Subject: Tidy Cleaners (BRRTS # 02-05-552220)

Ken – I recently had an opportunity to discuss Fehr Graham’s site investigation work plan proposal for the Tidy Cleaners site with the Northeast Region Closure Committee. As a result of that discussion, the DNR recommends the following modifications to the site investigation work plan proposal:

TITLE: PROPOSED SOIL BORINGS, MONITORING WELLS, & VAPOR POINTS		FEHR GRAHAM ENGINEERING & ENVIRONMENTAL	
SITE: Tidy Cleaners Green Bay, WI 54304		DATE: 9/19/12	FILE CODE: base map.skf
SCALE: 1"=20'	DESCRIPTION: TID-2010-01 14-1144	DRAWN BY: KAE	FIGURE 5

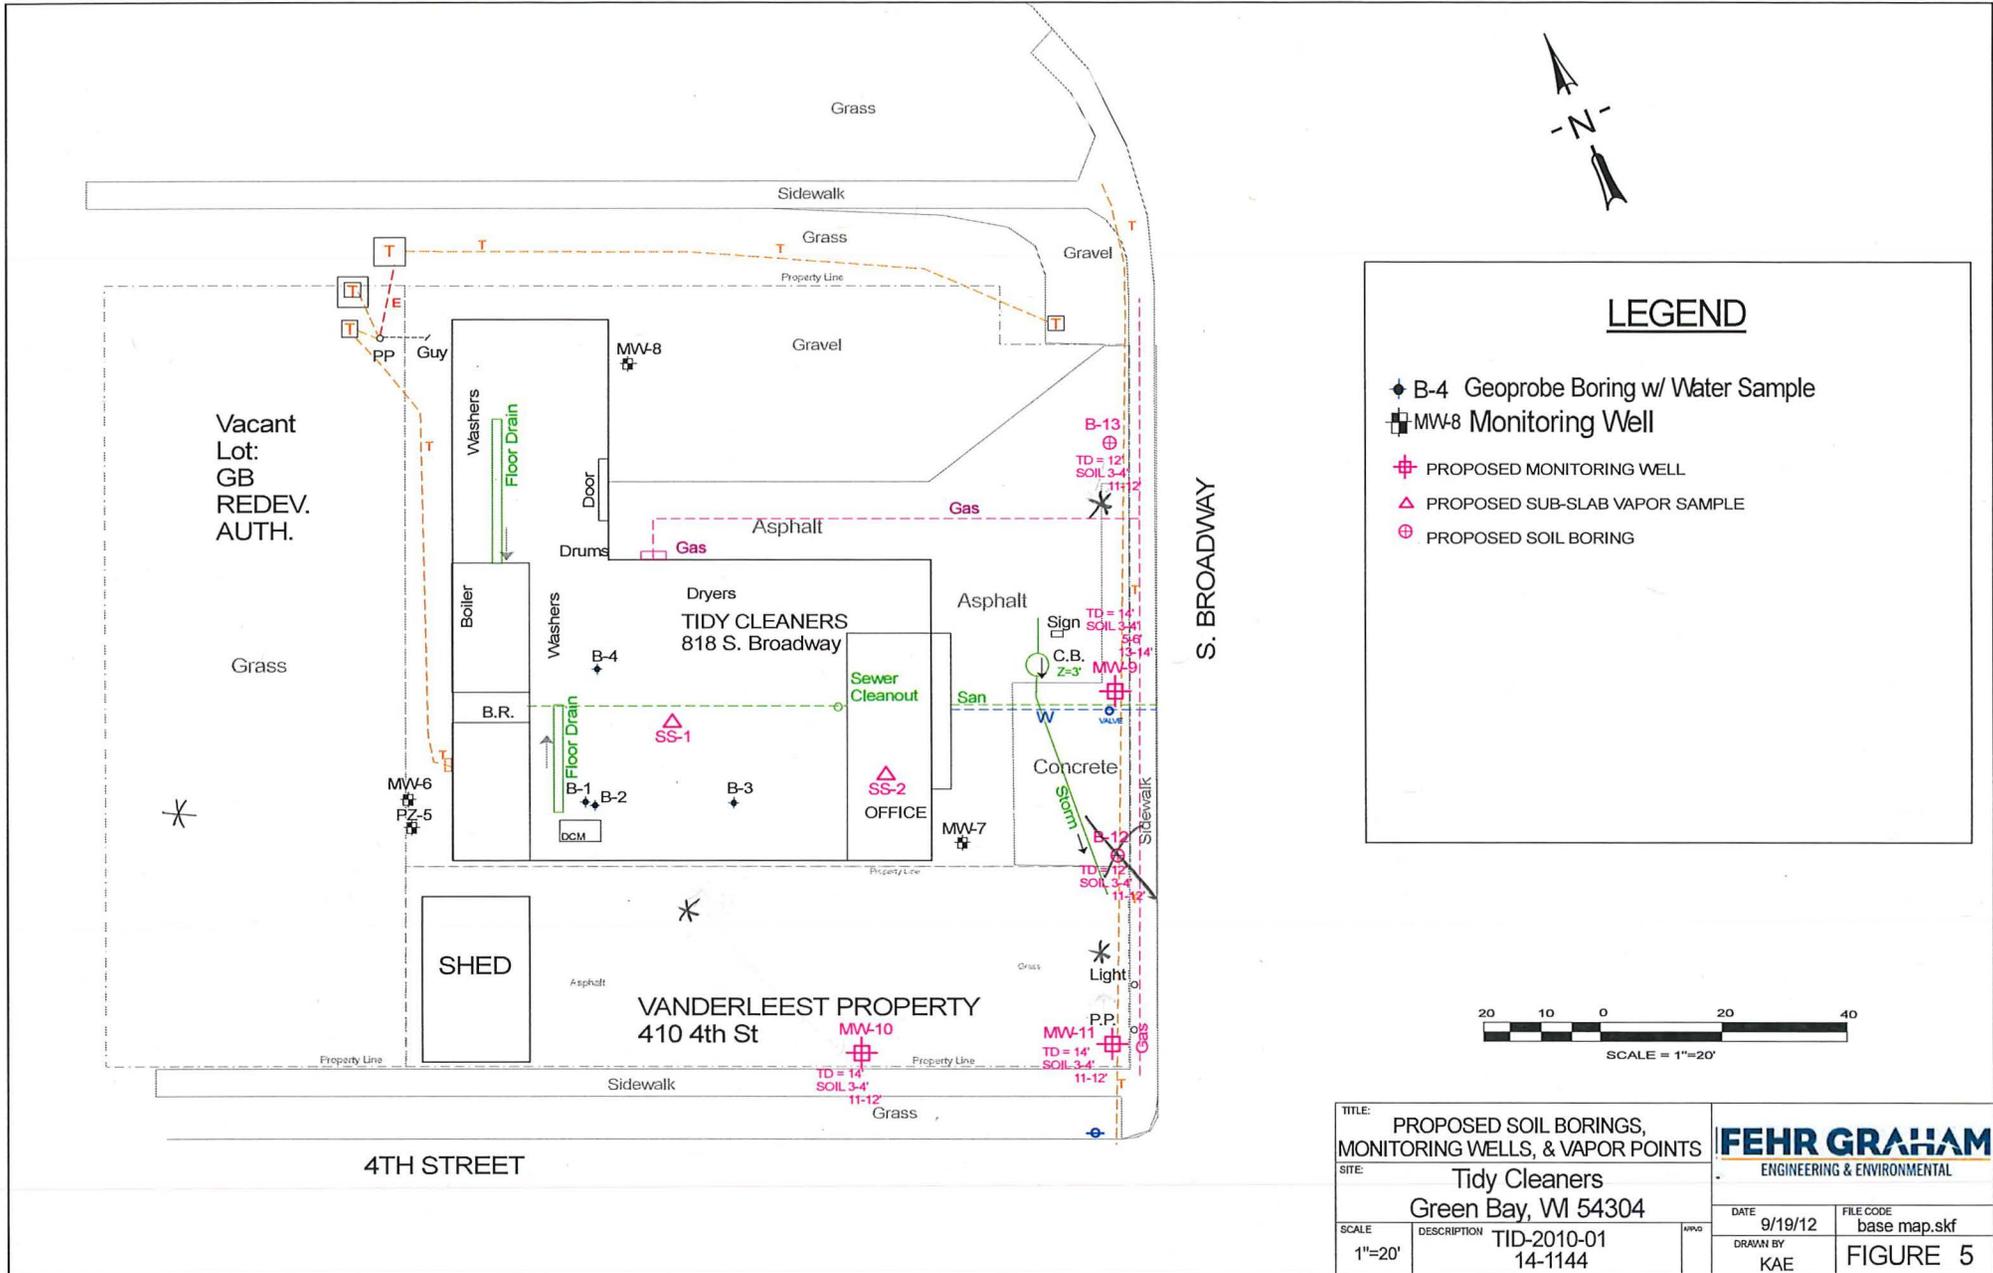
- Install a groundwater monitoring well up-gradient of monitoring well MW-6 (i.e. on the property identified as Vacant Lot: Green Bay Redevelopment Authority on the figures). Collect soil and groundwater samples from this location. Refer to the attached figure for a proposed location.

- Install a soil boring/monitoring well closer to the source area (i.e. on the property identified as Vanderleest Property on the figures). Collect soil and groundwater samples from this location. Refer to the attached figure for a proposed location. Note: You may want to consider moving proposed monitoring well MW-10 to this location.

- Relocate proposed monitoring well MW-11 to the north (i.e. closer to the light pole identified on the figures). Collect soil and groundwater samples from this location.

- Proposed soil boring B-12 can be eliminated.
- Relocate proposed soil boring -13 to the south so it is closer to the gas line. Collect soil and groundwater samples from this location. Refer to the attached figure for a proposed location. Note: The DNR recognizes the safety concerns associated with installing soil borings/monitoring wells near utilities and light poles. Please use caution and best professional judgement to determine the appropriate location for the proposed wells/soil borings.

- Install an additional piezometer. Consider nesting this piezometer with monitoring well MW-9 or MW-10 (see second bullet).

- The DNR is willing to accept one sub-slab soil sample location (i.e. SS-1) rather than two.
- If you haven't already, evaluate the utilities to determine if they are acting as migratory pathways.
